NFK 5HJ/1BL FILTER

APPROVED FOR CONSTRUCTION

WITH CORRECTIONS/CHANGES AS NOTED

NFK 5HJ/1BL FILTER APPROVED FOR CONSTRUCTION 11-1-01 WITH CORRECTIONS/CHANGES AS NOTED NO-LOSS STACK BY OTHERS 38"ø STACK FOR 21,000CFM RELEASE VELOCITY OF 3000FPM BY OTHERS REGENERATION FANS W/ 2 HP. 208,230/460V., 3 PH. TEFC MOTOR (M1) WEIGHT OF FILTER UNIT APPROX. 13,200 lbs. (PLUGGED) HOPPER DOOR LIMIT SWITCH 2 COND., 24VDC. CONTROL TO BE ELECTRICALY CONNECTED SO IF DOOR IS OPENED FILTER SYSTEM WILL SHUT DOWN. (TYP. BOTH ENDS OF FILTER) (HD1-HD2) $18' - 9\frac{1}{8}"$ NRS-10 ROTARY AIRLOCK 17'-75" -W/1 HP. 208,230/460V., 3 PH. TEFC MOTOR (RV1) (OPTIONAL) F.F. LEVEL $7'-6\frac{3}{4}"$ DRUMS & TRANSITION BY DANTHERM VIEW A - A PLEASE USE THE NFP SYLE DRUMS W/ HANDLES & VIEWING ELASS 1"=10'-0" SCALE:

1A150511

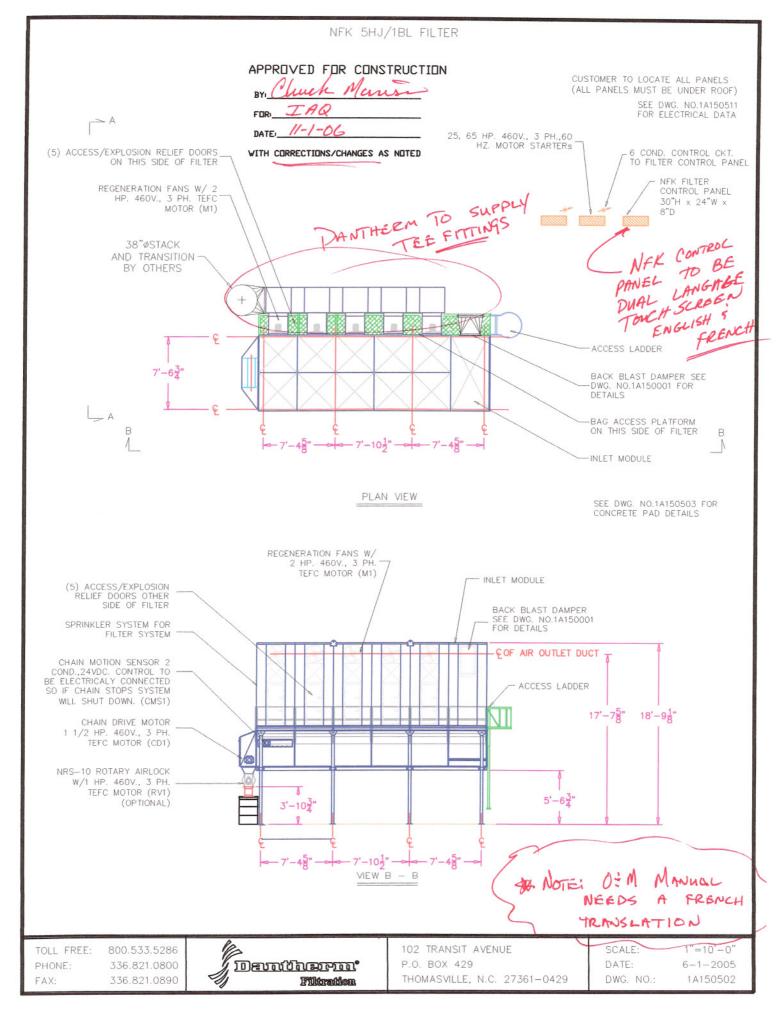
REVISE FLA./460V. 34 77 111 AMPS

5751/34
